**Subject:** DRAFT Response to U.S. EPR Design Certification Application RAI No. 442,  
FSAR Ch. 7, Question 7.1-26  
**Sent Date:** 3/21/2011 4:28:24 PM  
**Received Date:** 3/21/2011 4:28:48 PM  
**From:** WELLS Russell (AREVA)

**Request for Additional Information No. 442, Question 07.01-26**

**Question 07.01-26:**

Proposed changes to the I&C architecture were communicated to the NRC staff in the February 15, 2011 public meeting. U.S. EPR FSAR Tier 2, Section 7.1 will be revised to incorporate the revised I&C architecture. This section is provided in its entirety with this response to facilitate NRC review.

Figure 7.1-2—~~U.S. EPR I&C Architecture~~ Distributed Control System Functional Architecture

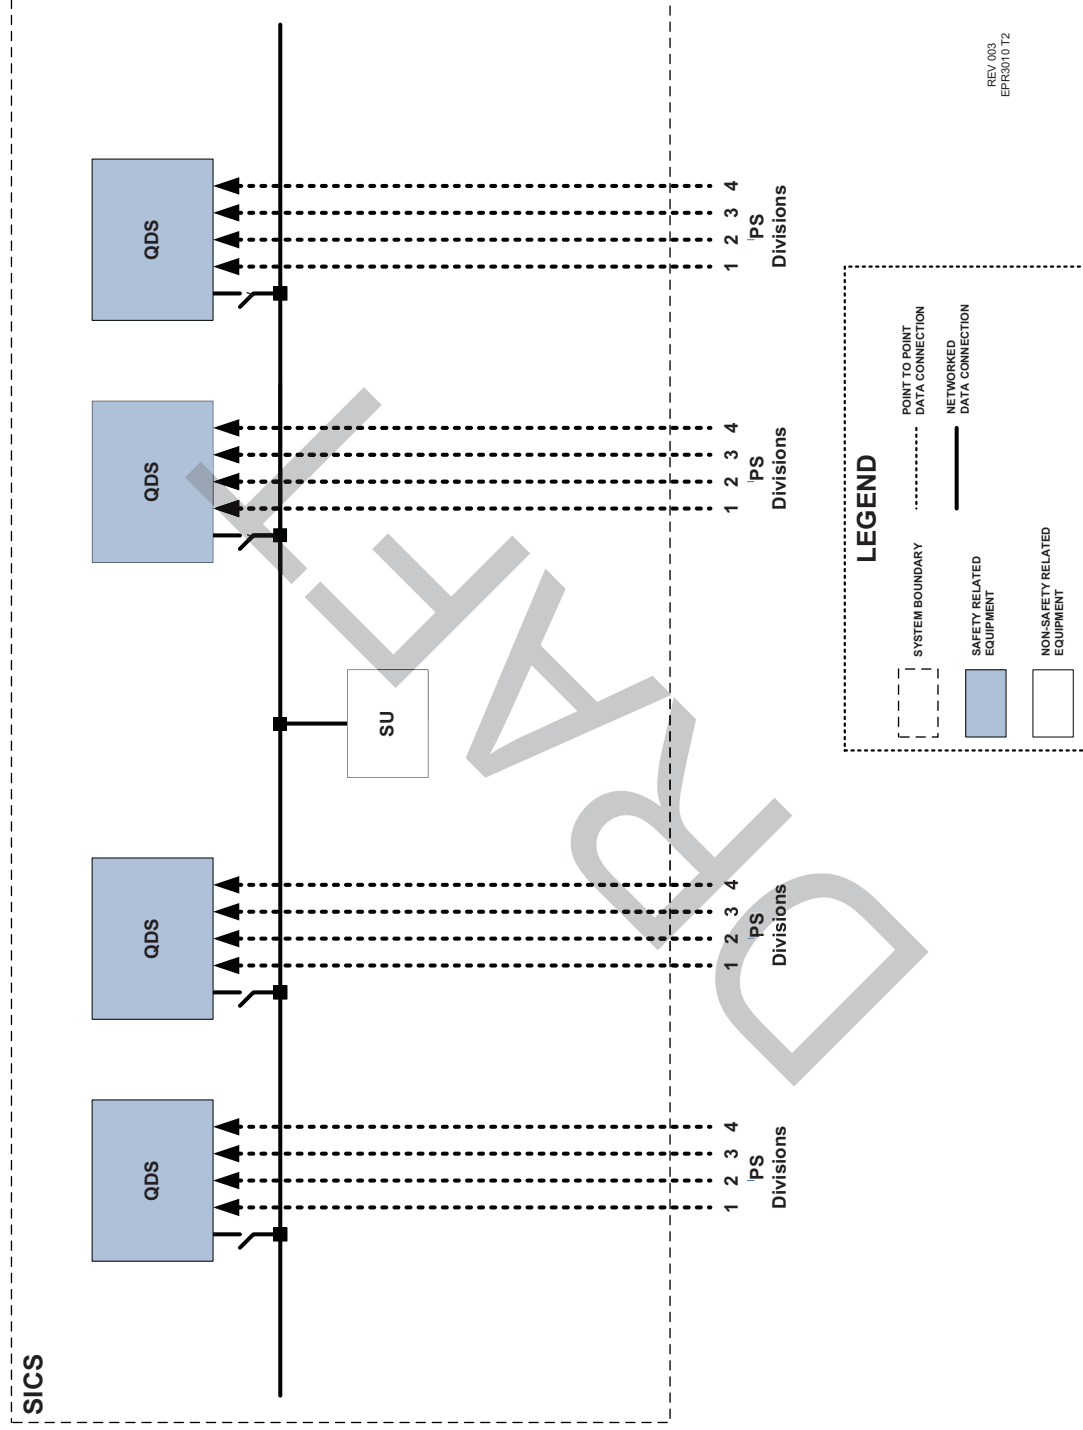
Figure 7.1-2 shows the basic architecture of the SICS.

07.01-26

Figure 7.1-9—~~Severe Accident I&C System Architecture~~ Deleted

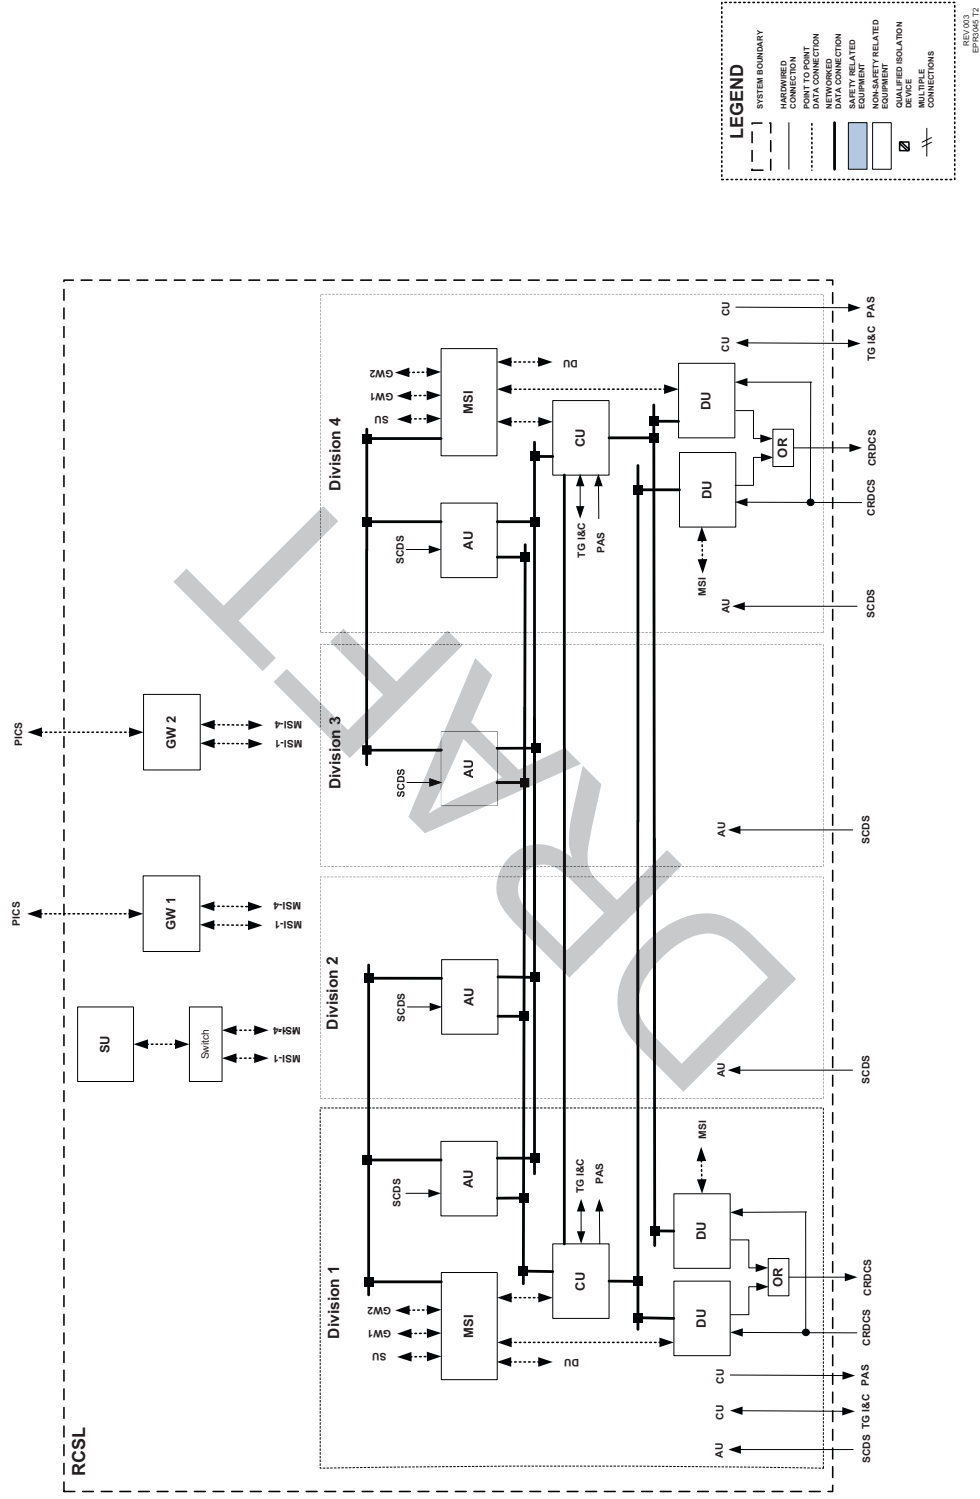
~~Figure 7.1-9—Severe Accident I&C System Architecture provides a functional representation of the SA I&C.~~

Figure 7.1-19—Implementation of Independence Between Redundant Divisions

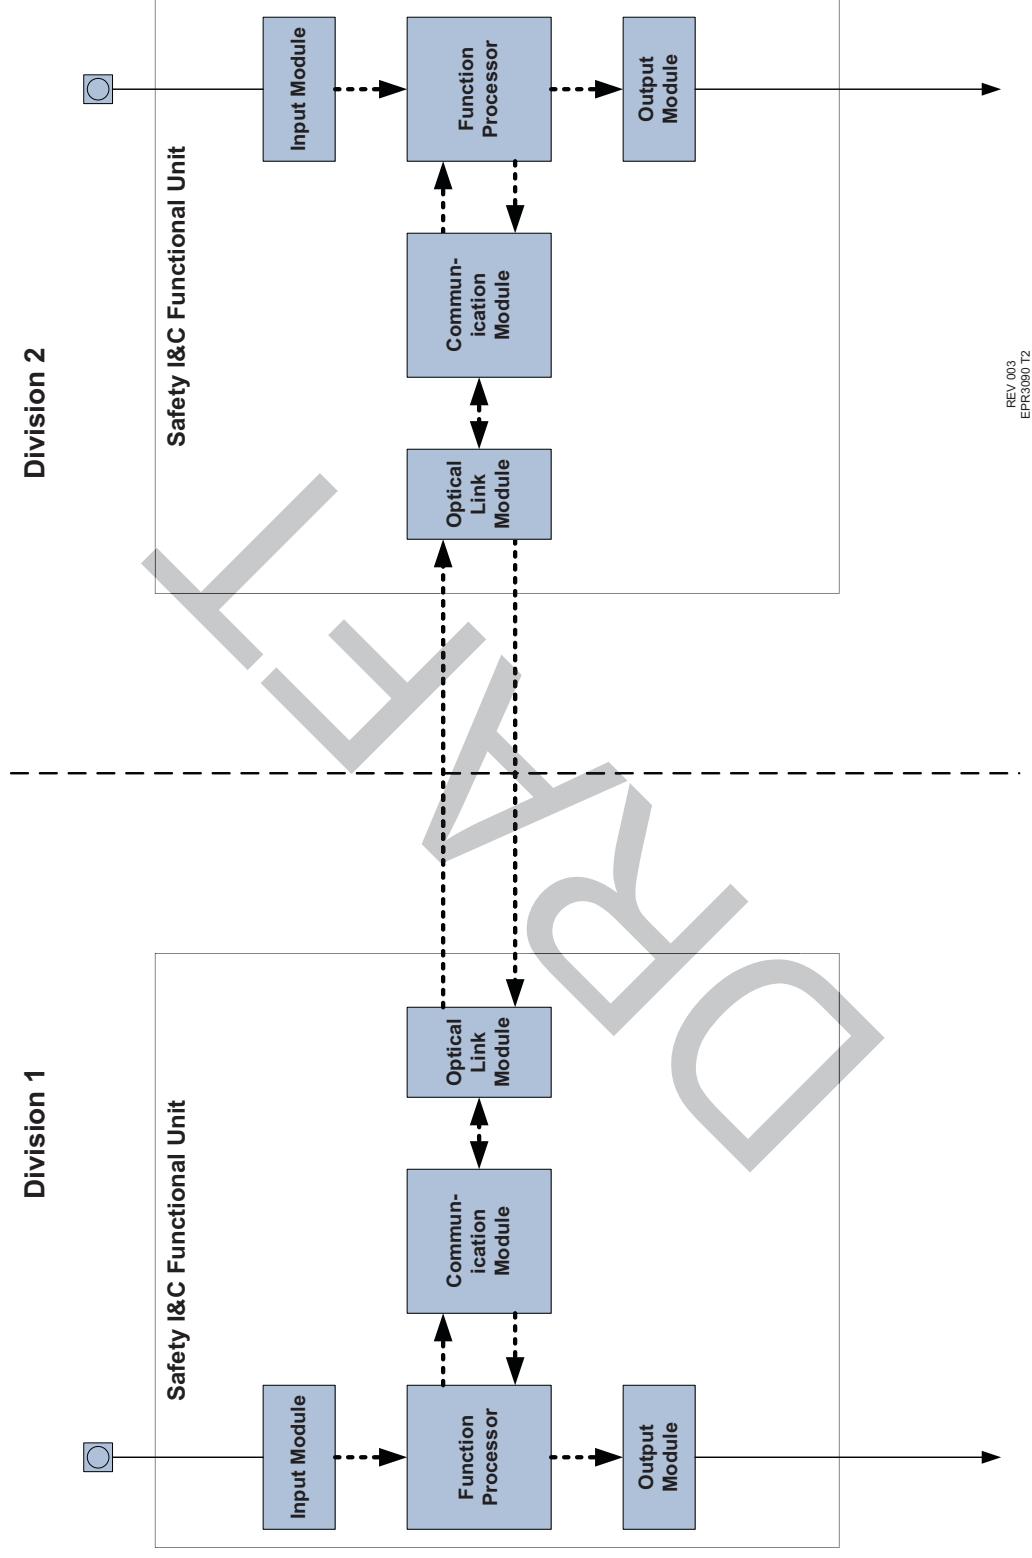
07.01-26

Figure 7.1-20—Implementation of Independence Between Safety and Non-Safety I&C

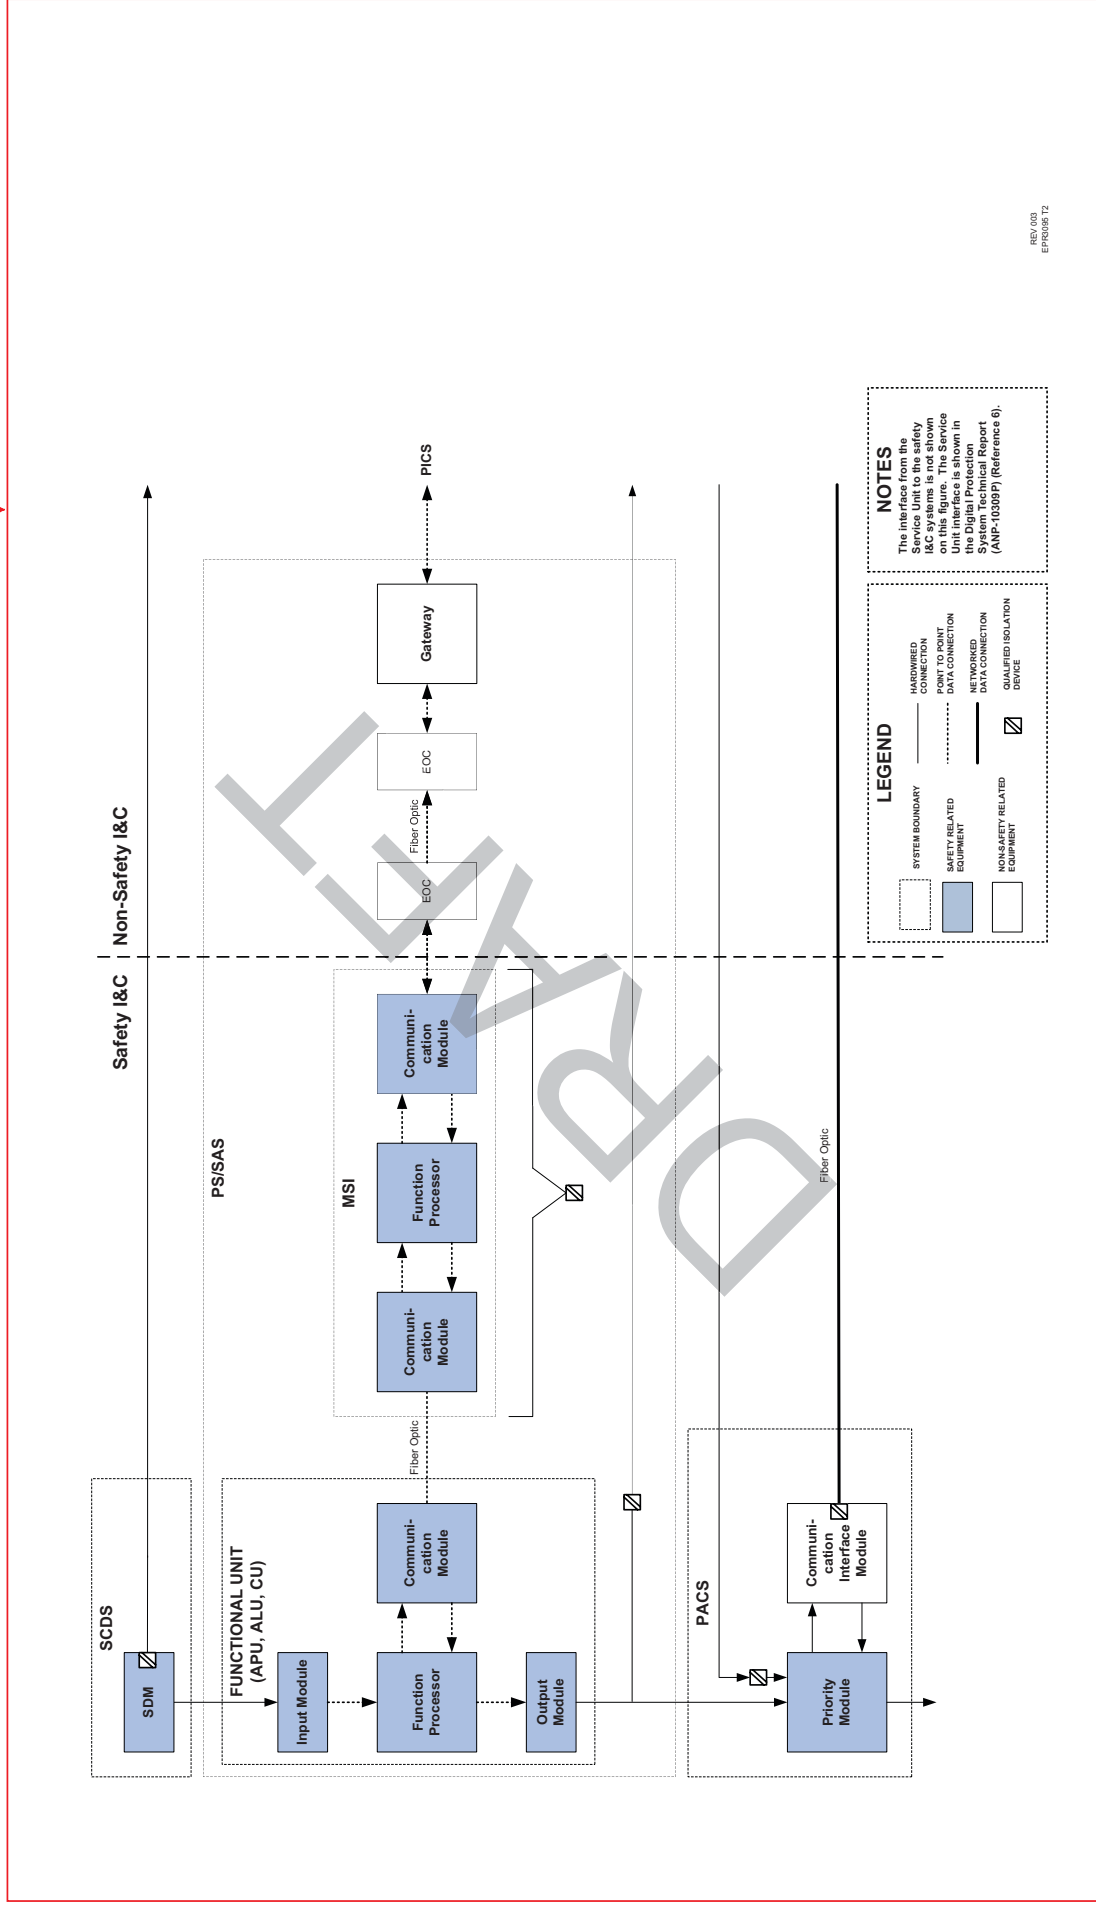
07.01-26

Figure 7.1-24—Self Powered Neutron Detector Functional Arrangement

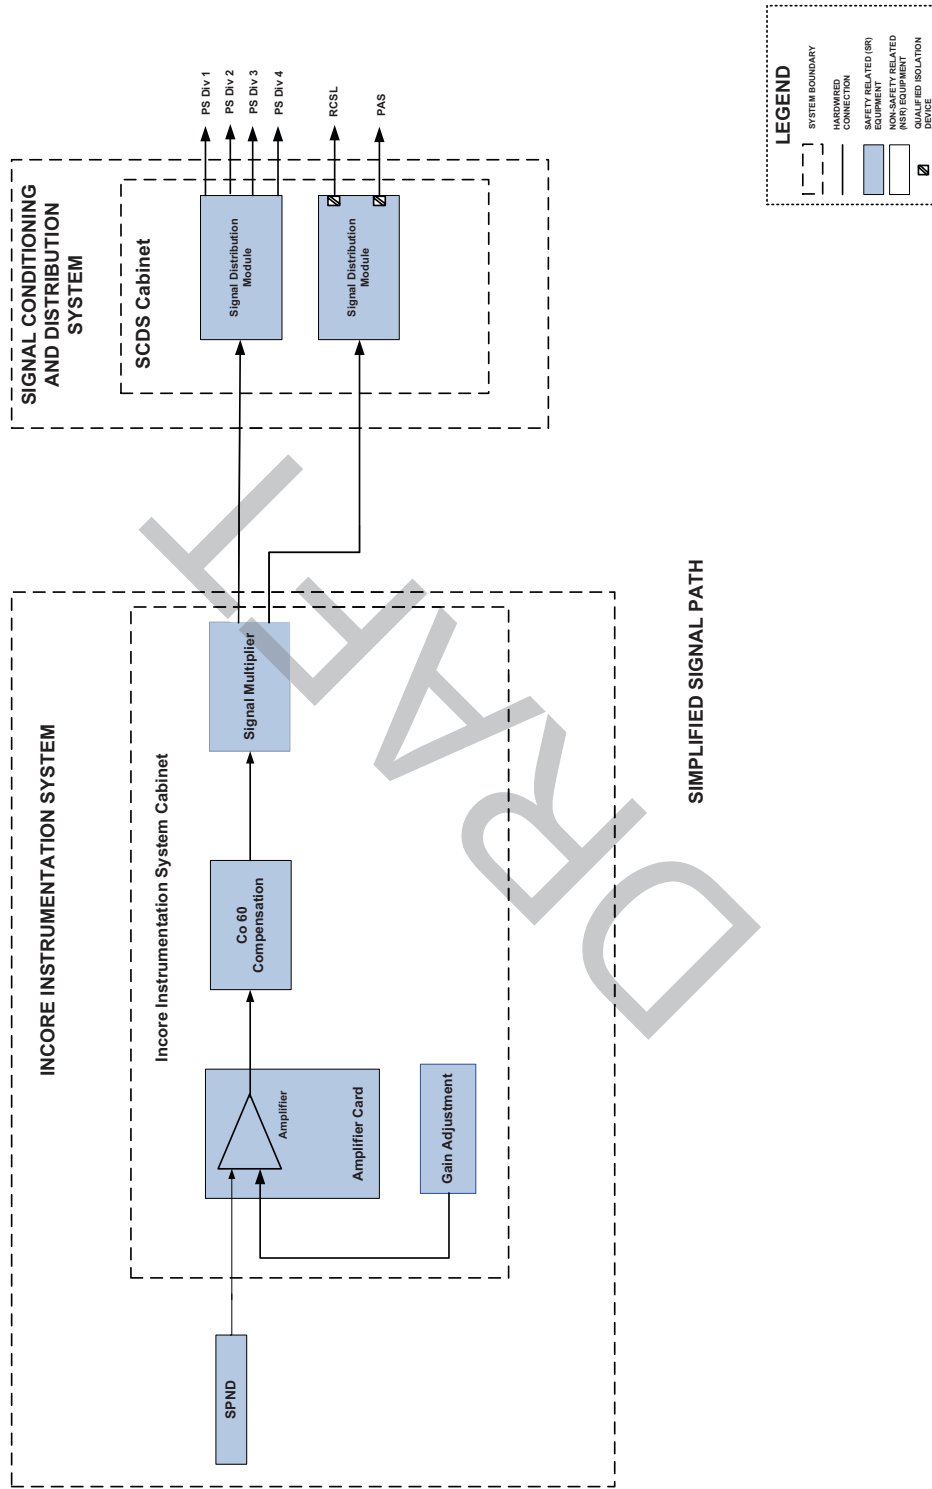
Figure 7.1-24—Self Powered Neutron Detector Functional Arrangement shows the signal path of the SPNDs through the incore equipment into the SCDS for distribution in the other DCS systems.
